Technical Service Bulletin

L6D Camera Firmware v1.6.0

Time Zone selection in Setup Wizard [HDP-3700]

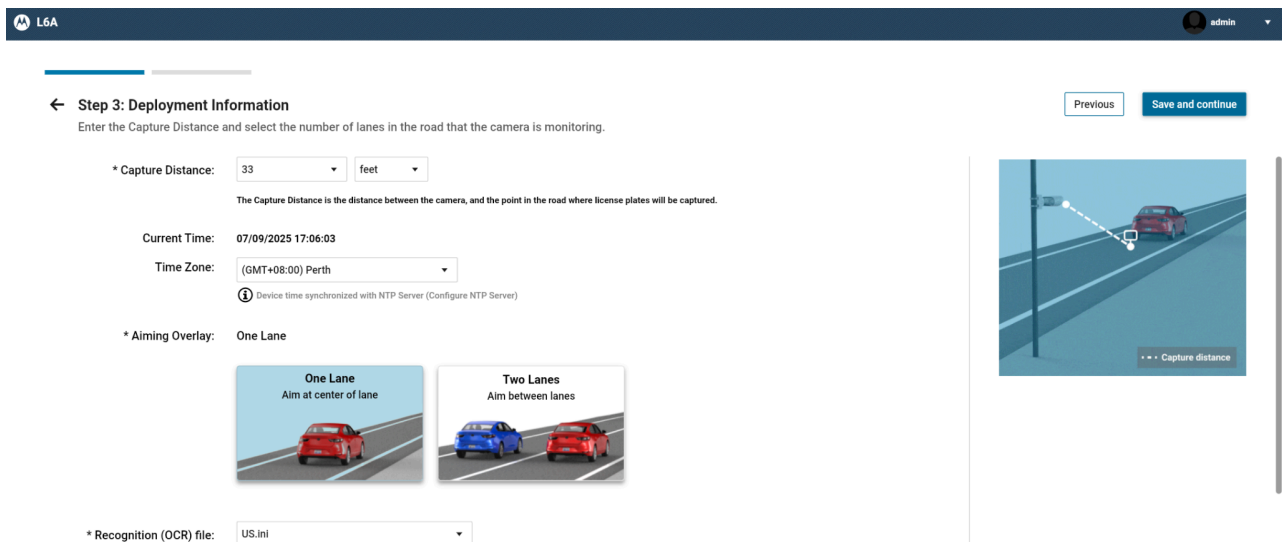
The **Setup Wizard** now supports the automatic setting of the system time and time zone when the GPS location of the camera is set.
